SUBJECT: U.S. NUCLEAR REGULATORY COMMISSION ONSITE OBSERVATION
REPORT FOR THE IDAHO NATIONAL LABORATORY IDAHO NUCLEAR
TECHNOLOGY AND ENGINEERING CENTER TANK FARM FACILITY

ML102770022

**IDAHO NATIONAL LABORATORY IDAHO NUCLEAR TECHNOLOGY AND ENGINEERING
CENTER TANK FARM FACILITY
U.S. NUCLEAR REGULATORY COMMISSION ONSITE OBSERVATION REPORT**

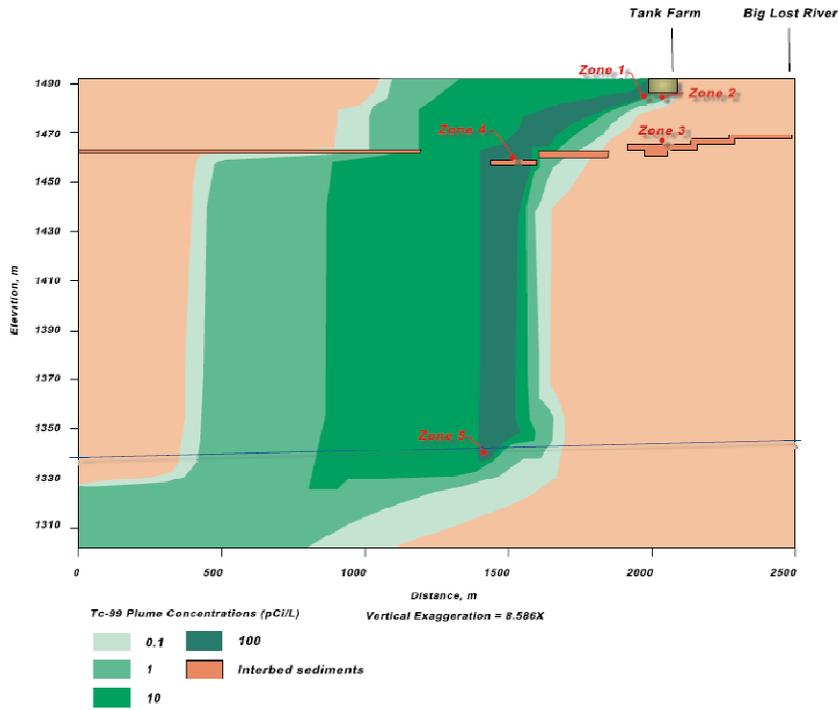
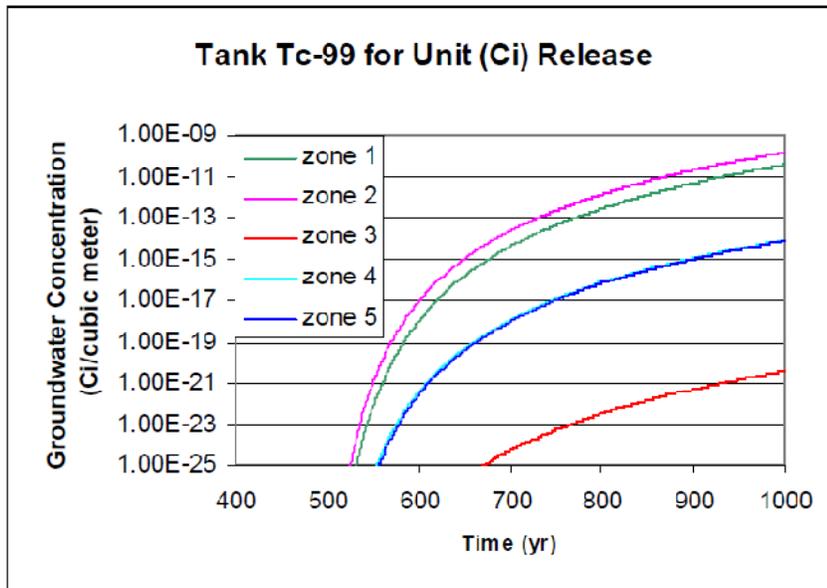
Monitoring of perched and saturated groundwater is conducted in part to determine the effectiveness of remedial actions to help ensure protection of human health. NRC staff was provided an opportunity to discuss groundwater monitoring issues identified during its review of DOE's PA for the INTEC TFF (DOE Idaho, 2003) with DOE contractors working on CERCLA-related environmental monitoring programs. DOE contractor staff confirmed Performance Assessment Branch staff understanding of recent CERCLA monitoring results that indicate that only monitoring wells located very close to the Big Lost River (BLR) north of the INTEC facility show a water level response following rare occasions when BLR flow occurs on site. DOE contractors indicated that BLR flow is currently thought to have little impact on perched water further away from the river near INTEC facilities, contrary to initial assumptions. Rather, anthropogenic sources of water are thought to have a much larger affect. DOE contractor staff also presented data on perched and SRPA groundwater sampling at INTEC. NRC staff review of this data indicates that known piping releases from INTEC are in close proximity to the facility with limited lateral movement primarily to the southeast of the facility (NRC, 2008; NRC, 2009) and in some cases potentially to the north of the facility (DOE Idaho, 2004).

The data presented by DOE is consistent with NRC staff's understanding of the recently revised hydrogeological conceptual model of the INTEC TFF based on its review of monitoring and modeling activities conducted under the CERCLA program. However, as documented in NRC staff's TER and monitoring reports (NRC, 2006; NRC, 2008; and NRC, 2009), the monitoring results appear to be inconsistent with DOE PA modeling (DOE Idaho, 2003) predictions that show a very large impact of BLR flow on contaminant flow and transport of future TFF releases. As stated in a response to a follow-up Request for Additional Information (RAI) (DOE Idaho, 2006a), the large lateral extent of the modeled contaminant plume diverted laterally approximately 600 meters to the south of the TFF (see Figure 1 below) is due completely to the pressure gradient that results from the steady-state infiltration boundary condition for the BLR. In this response, DOE goes on to state that the large lateral extent of the contaminant plume is not indicative of perched water. As documented in NRC staff's TER (NRC, 2006), DOE's response to NRC's inquiry regarding the cause of the large lateral spread (DOE Idaho, 2006a) appears inconsistent with explanations provided in the actual PA documentation itself (DOE Idaho, 2003)—DOE's PA indicates that the numerical model predicts contaminant transport around the perched zones and through breaks in the interbeds. In fact, the numerical model results show no perched zones along or near the flow path of the contaminant plume as described in the PA making the relevance of the statement regarding perched water unclear. Additionally, there is no indication from the monitoring data that when BLR flow does occur that contamination could be deflected nearly half a mile laterally to the south of the TFF. Due to the uncertainties in the PA modeling predictions and due to the large amount of credit that appears to have been given to vadose zone performance in DOE's PA model with respect to dilution (approximately four orders of magnitude or a factor of 10,000 as shown in Figure 2 below [see difference in peak concentrations between zones 1 and 2 at the source and zone 4 at the vadose zone "spill-way" provided in DOE, 2006b]), NRC staff continues to recommend that DOE consider new and significant information collected under the CERCLA program in decisions to update its PA or in any future updates to its PA. Additionally, vadose zone transport mechanisms are important as they impact remediation and monitoring. For example, if this phenomena (i.e., large lateral deflection of INTEC TFF releases due to BLR imposed pressure gradients) actually occurs at INTEC or were to occur in the future, it could complicate remediation and monitoring of historical releases or monitoring of future releases that may occur from the INTEC TFF.

In fact, DOE indicated that it is in the process of determining whether its PA model needs to be updated. Given the risk significance of the groundwater model and additional CERCLA data that has come to light since development of the PA, NRC staff specifically recommended that DOE update its PA documentation (through an errata sheet or other textual revision) to clarify the cause of the lateral spreading of the contaminant plume and its risk significance as documented in responses to NRC RAIs (see DOE Idaho, 2006a and DOE Idaho, 2006b). NRC staff also recommended that DOE consider data and modeling conducted under the CERCLA program that has resulted in a revised hydrogeological conceptual model for the INTEC in determining whether to conduct additional modeling in an update to its PA.

NRC and DOE staff discussed monitoring conducted under the CERCLA program for the INTEC facility. NRC staff made two recommendations for DOE to consider in its decision to update the PA. NRC staff recommended that the PA reflect the results of simulations performed and additional documentation generated during the NDAA consultation process to answer NRC staff inquiry regarding the cause and performance impact of the significant lateral spread of the contaminant plume emanating from the TFF to the south (e.g., caused by pressure gradient from BLR seepage and resulted in up to a factor of 10,000 decrease in contaminant concentrations emanating from the tank farm facility for relatively mobile [non-sorbing] constituents such as Tc-99 and I-129). NRC staff also recommended that DOE consider (in its decision to update the PA) recent data collected under the CERCLA program that appears to be inconsistent with the DOE PA modeling results with respect to the impact of BLR flow on contaminant fate and transport at the INTEC TFF. NRC staff recommends that DOE should consider the new information in the next update to its PA maintenance plan.
